Technical Service Bulletin: TSB230007

New Fuel Pump Accessory Drive and Electronic Chip Detector

Figure 1, Wiring Harness Connection and P-clip Locations.

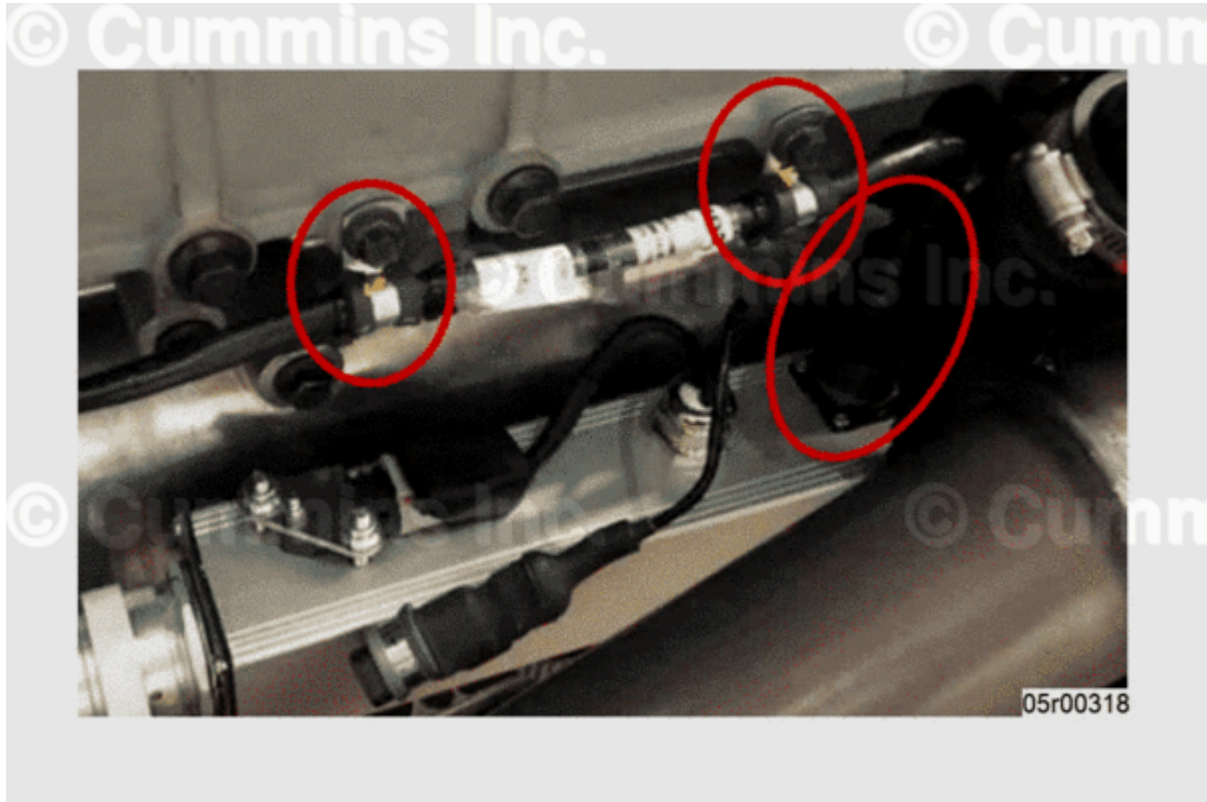
- Connect extension harness, Part number 5542339, to left bank main engine wiring harness as shown in Figure 1.
- Install two P clips as shown in Figure 1.

Torque Value: 33 n·m [24 ft-lb]

Figure 4, P-clip Location on Fuel Pump Accessory Drive.

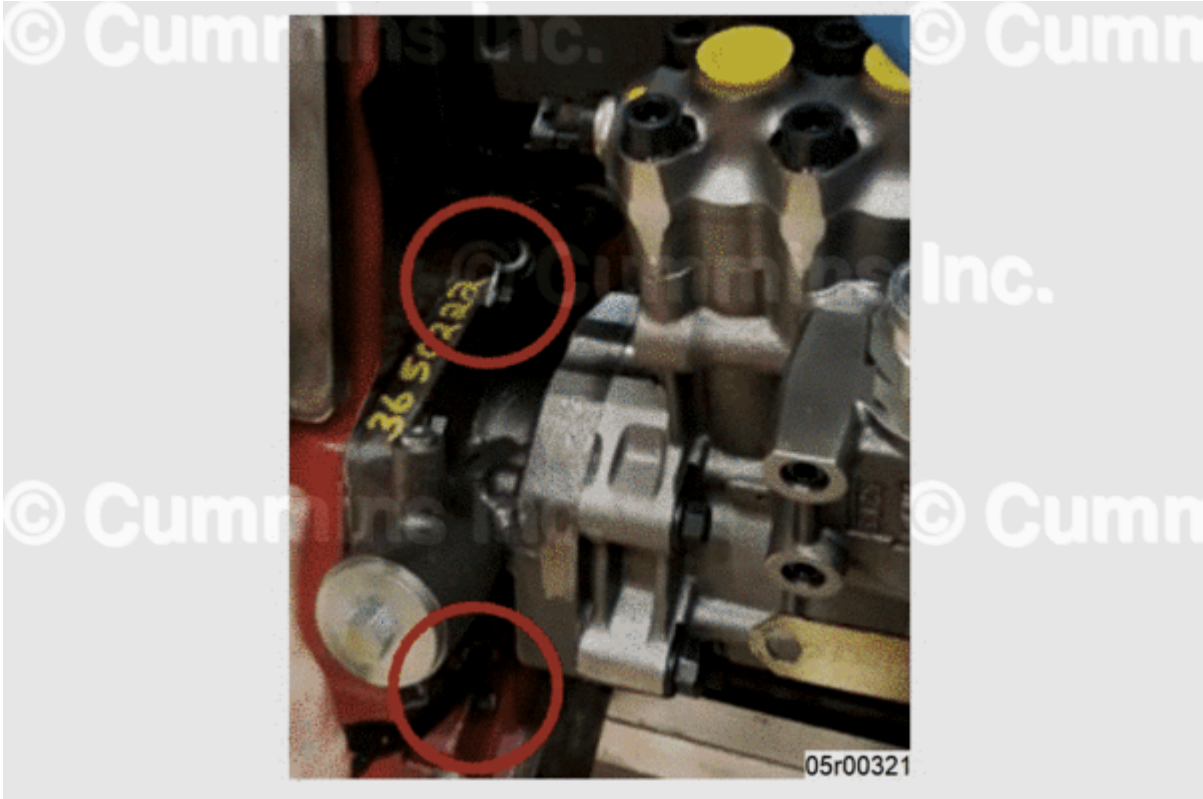
- Install two P-clips to the fuel pump accessory drive as shown in Figure 4.

Torque Value: 45 n•m [33 ft-lb]
